DEVELOPMENT REVIEW BOARD
SUPPLEMENTAL SUBMITTAL

PROJECT NO. PR-2021-005459

SUBMITTAL DESCRIPTION: Response to DRB Comments Letter, Revised Site Plan and details addressing Transportation

**RE: PR-2021-005459 RESPONSE TO DRB COMMENTS
LOT 1A BLOCK 2 & LOT 2-A-1 BLOCK 2 SUNPORT PARK
2900 TRANSPORT ST NE**

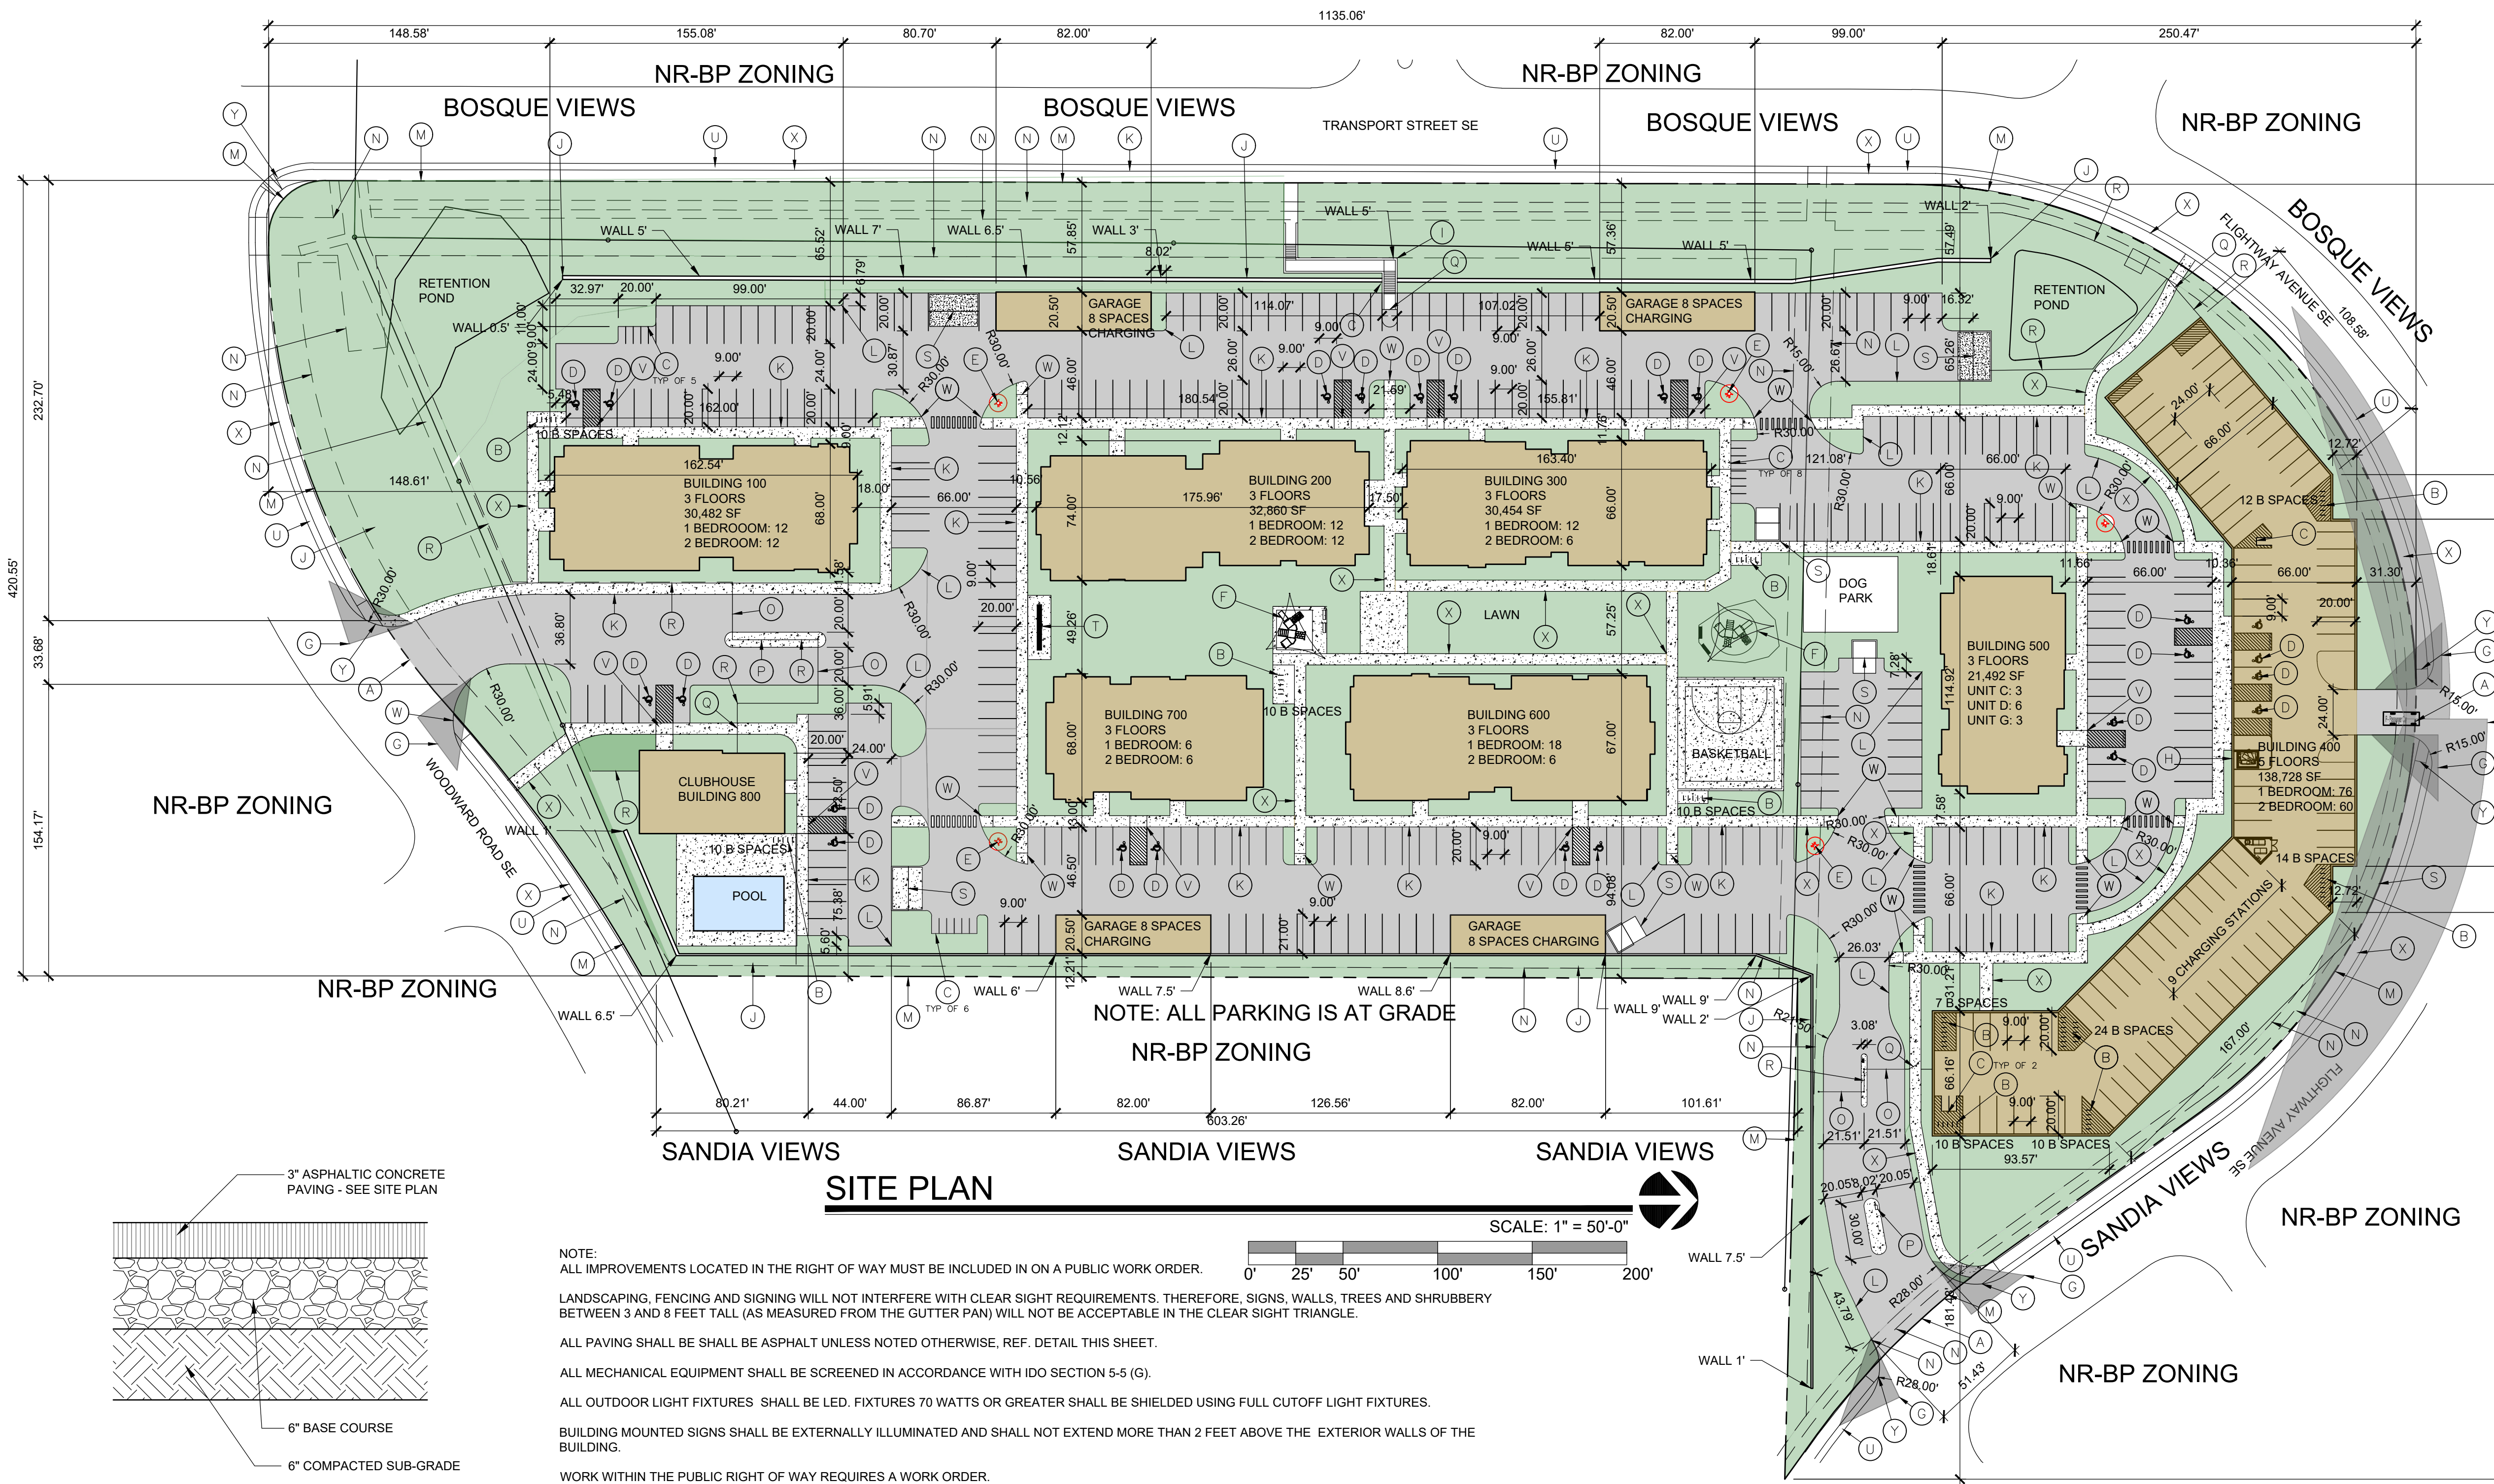
3. Please refer to the picture below regarding façade design suggestions.

RESPONSE: Reference the updated 3D images and the revised building elevations for building 400.

DESIGNED	PROJECT NO
	DRAWN	SCALE
	CHECKED	DRAWING NO
	REVIEWED	
DATE 10/14/2021		A-001

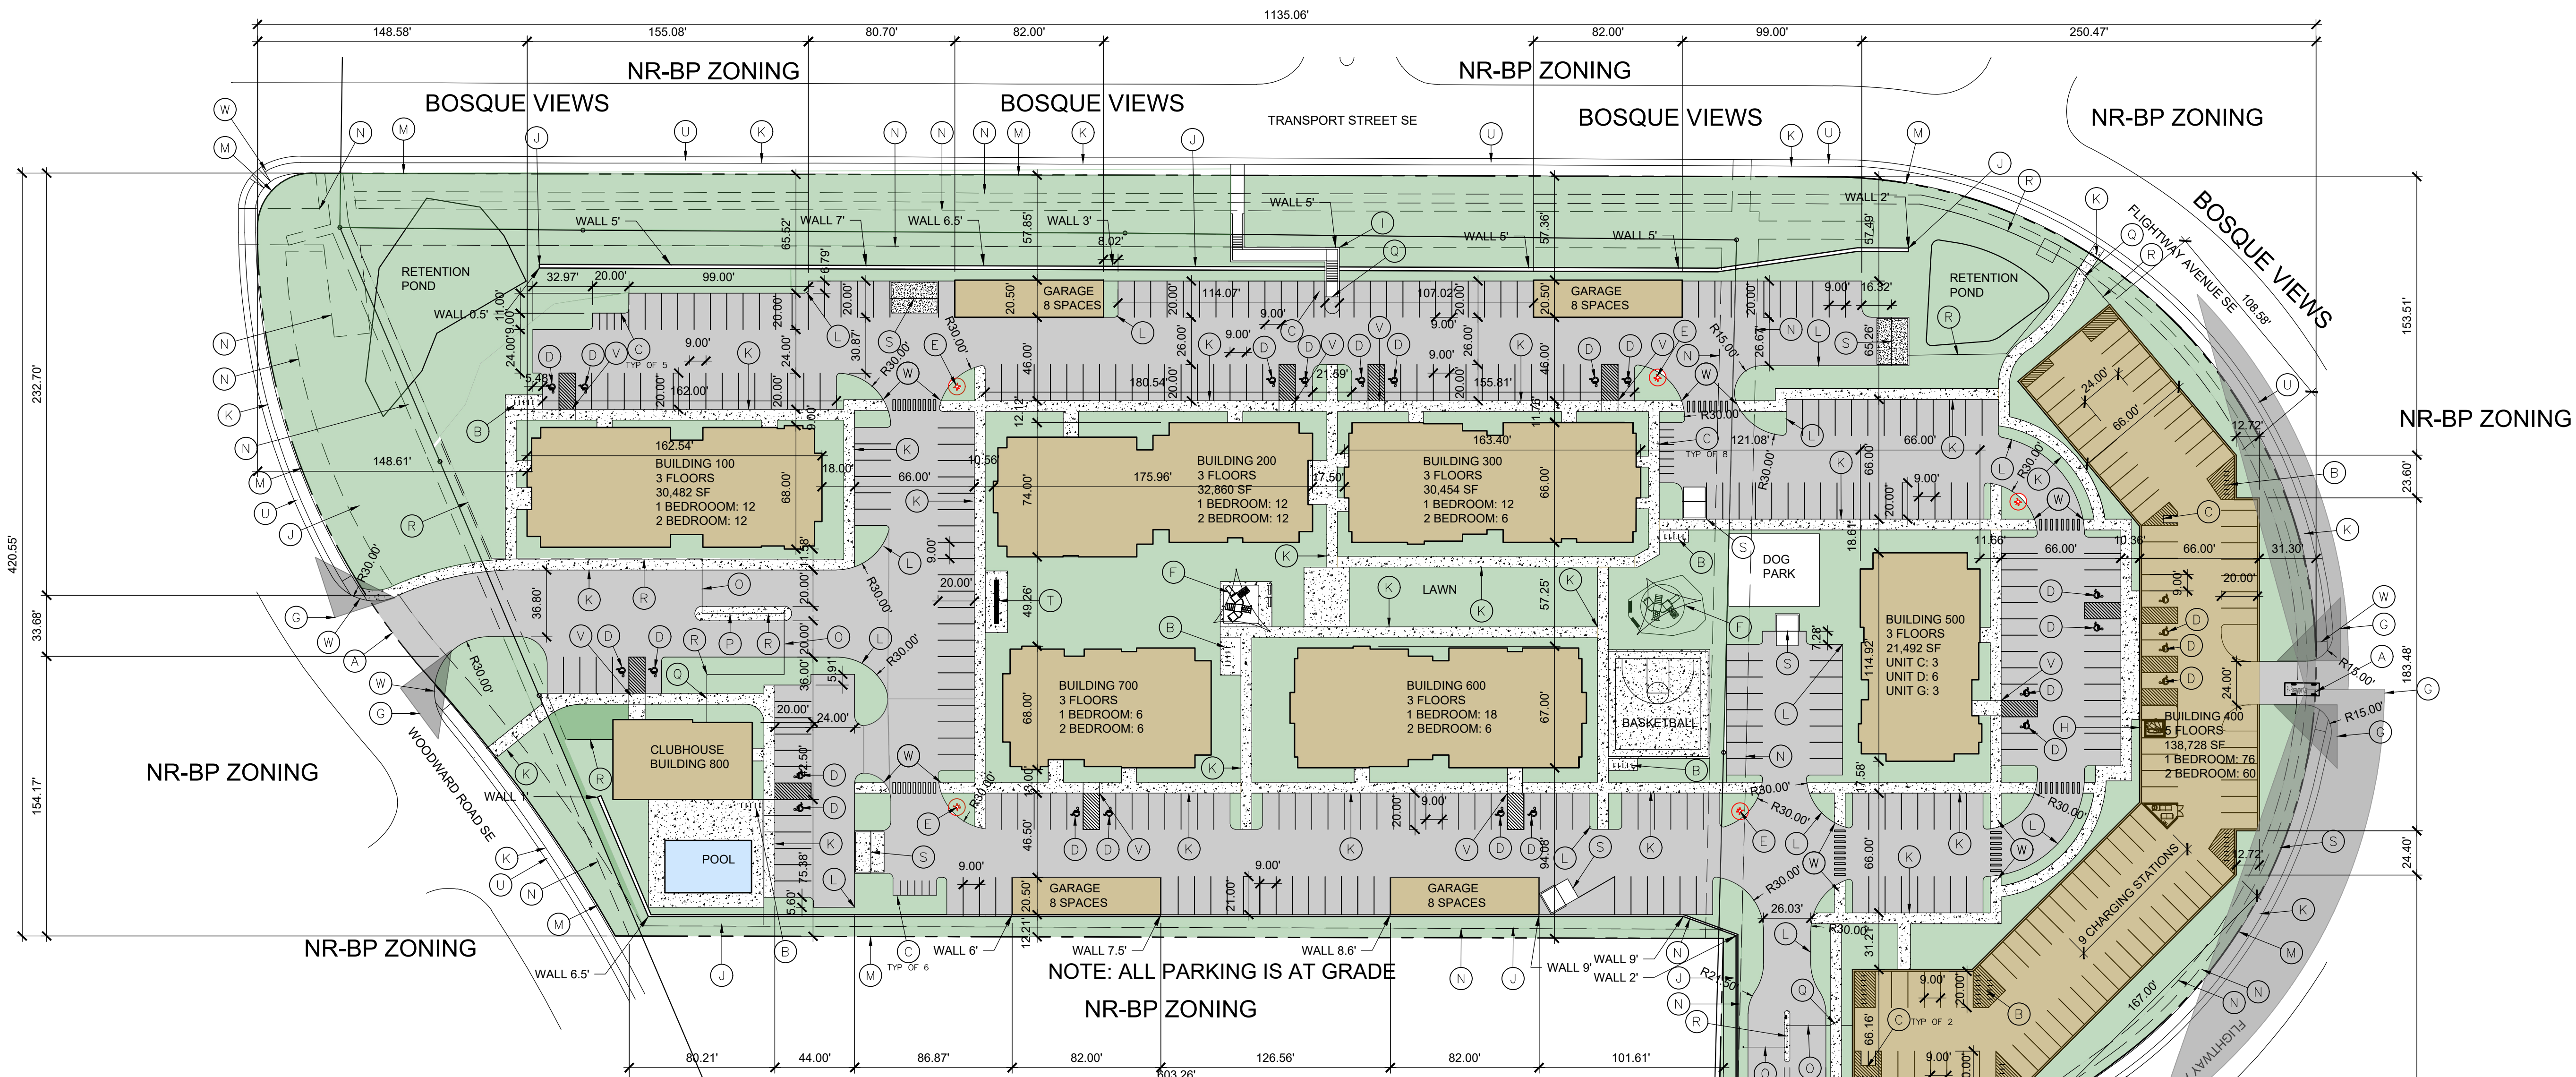
1. Roadway dimensioning for the east accessway is unclear. Because there are different dimensions for aisles, overall parking lot widths, and parking space lengths throughout the site, label typical dimensioning for each of the parking lot segments. (Two of the dimensions for the east accessway are shown in the thousands.)

3. To show 70 parking spaces outside of buildings, label number of bicycle parking spaces at each area labeled Keyed Note "B". (Dimension overall bicycle parking based on number of spaces.) Also, indicate electrical charging stations on the plan.

5. Make sure all ramps on-site are called out on the site plan. When referencing standard details 2442 and 2443, call out the correct detail reference from each of these COA drawings.

7. Please add a note on the plan stating "All improvements located in the Right of Way must be included on a public work order."

RESPONSE: Roadway dimensioning has been revised on Sheet A-001 with an architectural stamp date of 10/14/21.
2. For Keyed Note K on the turndown edges, these would typically apply to areas along the parking lot. Make a distinction with keyed note between areas that have turndown edges versus no turndown edges. Provide a detail for the sidewalk turndown edge, too.

RESPONSE: Bicycle parking spaces and quantities have been added to the site plan.
4. The ADA access aisle shall have the words "NO PARKING" in capital letters, each of which shall be at least one foot high and at least two inches wide, placed at the rear of the parking space so as to be close to where an adjacent vehicle's rear tire would be placed. (66-1-4.1.B NMSA 1978)

RESPONSE: Ramps have been called out. Wording to keyed notes V and W have been edited to include specific City Standard Details. Keyed note Y added to call out City Work Order ramps.

RESPONSE: Note added to A-001 "ALL IMPROVEMENTS LOCATED IN THE RIGHT OF WAY MUST BE INCLUDED ON A PUBLIC WORK ORDER"
